UNITED STATES  
NUCLEAR REGULATORY COMMISSION  
WASHINGTON, D. C. 20555

SUBJECT: UPPER HEAD INJECTION SYSTEM REMOVAL, BORON INJECTION TANK  
DEACTIVATION, AND CLOSEOUT OF TEMPORARY 50.46(a)(1) EXEMPTION  
(TAC 75748, 75750, 76678) (TS 89-25 and 89-26) -  
SEQUOYAH NUCLEAR PLANT, UNIT 2

TENNESSEE VALLEY AUTHORITY  
DOCKET NO. 50-328  
SEQUOYAH NUCLEAR PLANT, UNIT 2  
AMENDMENT TO FACILITY OPERATING LICENSE

Amendment No. 131  
License No. DPR-79

Figure 3.2-2  
K(Z) - Normalized Fq(Z) as a Function of Core Height

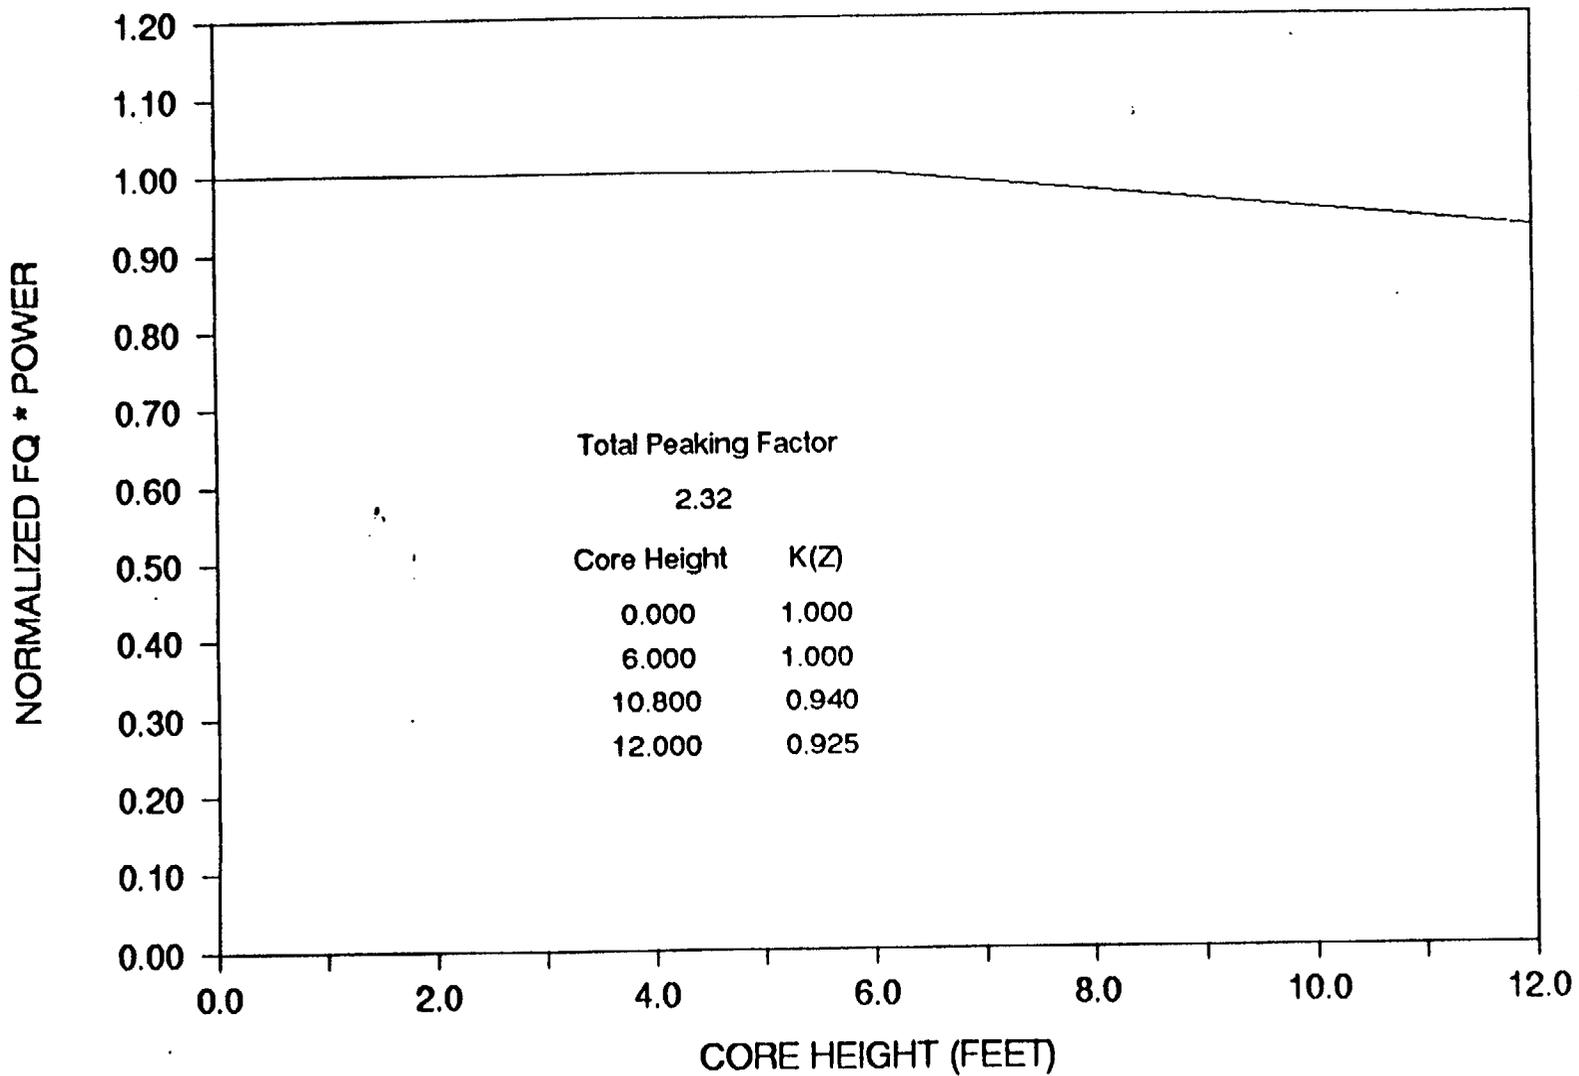
The proposed change would revise the total peaking factor from 2.15 to 2.32 and also replace Figure 3.2-2, the  $K(z)$ , i.e., the normalized  $F_Q(Z)$  curve.

$$F_Q(Z) \leq \frac{[2.32]}{P} [K(Z)] \text{ for } P > 0.5$$

$$F_Q(Z) \leq \frac{[2.32]}{0.5} [K(Z)] \text{ for } P \leq 0.5$$
